250439 - 81-83 George St & 1 Barrack Ln, Parramatta - Response to HNSW Comments - R1

TO: Katherine McIntosh **DATE:** 14 January 2026
COMPANY: Mecone
EMAIL: kmcIntosh@mecone.com.au
FROM: JackL@pwna.com.au
SUBJECT: 81-83 George St & 1 Barrack Ln, Parramatta – Response to HNSW Comments – R1

Figure 1 Map identifying locations of heritage items and proximity to site.

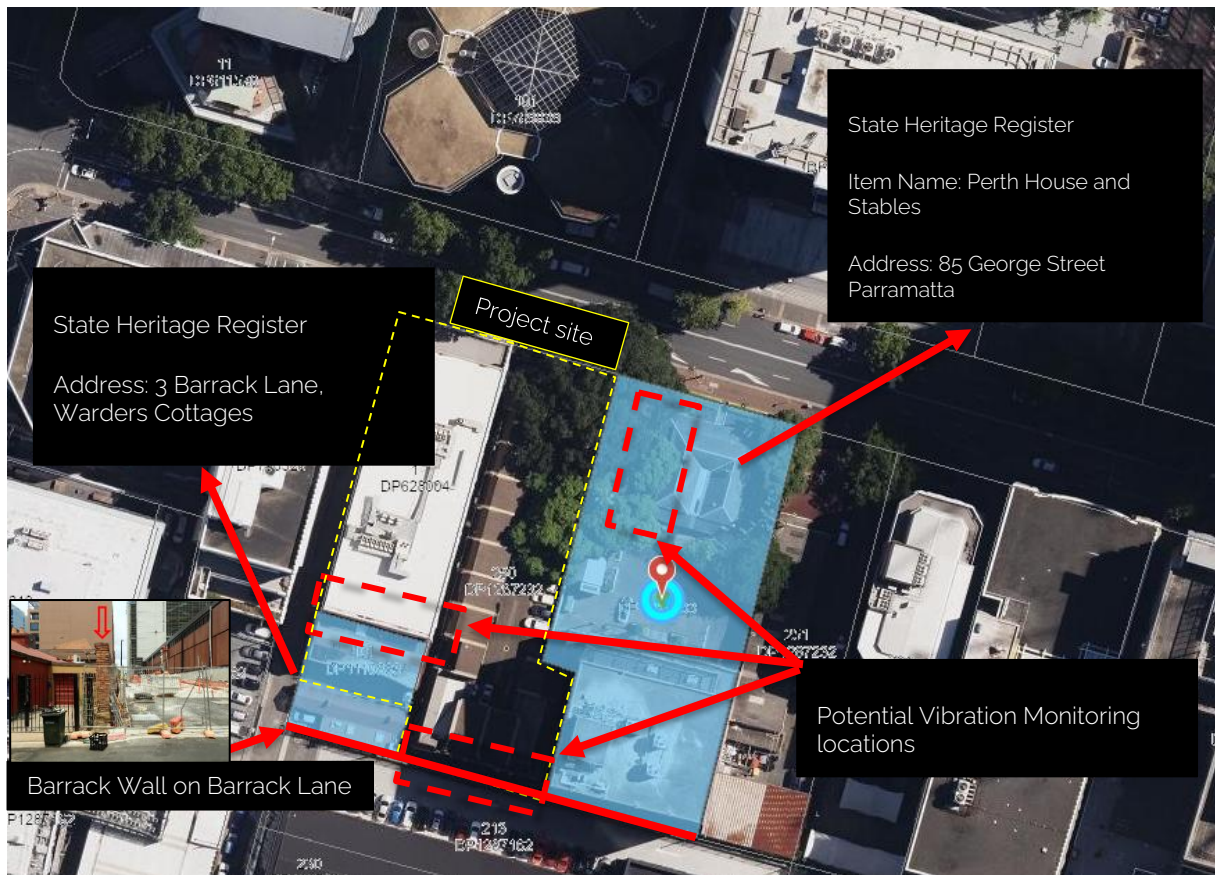
8. The Noise and Vibration Impact Assessment (NVIA) in Appendix Z of the EIS does not identify the heritage items adjacent to the site (Perth House and Stables, Warders Cottages and Convict Barracks Wall). Please confirm that the findings and recommendations of the NVIA report in relation to construction vibrations would be relevant to these items or update the report as required, noting that the SSD is in very close proximity to the heritage items.

Given the close proximity of the SSD to the identified heritage items, the vibration criteria, mitigation measures, monitoring requirements, and management recommendations set out in the submitted Noise and Vibration Impact Assessment (NVIA) are also intended to apply to the heritage items identified below in Table 1.

A review of the State Heritage Inventory and Schedule 5 of the Parramatta Local Environmental Plan (LEP) 2023 was undertaken to identify the listed Heritage items. These heritage items are indicated in Figure 1 below.
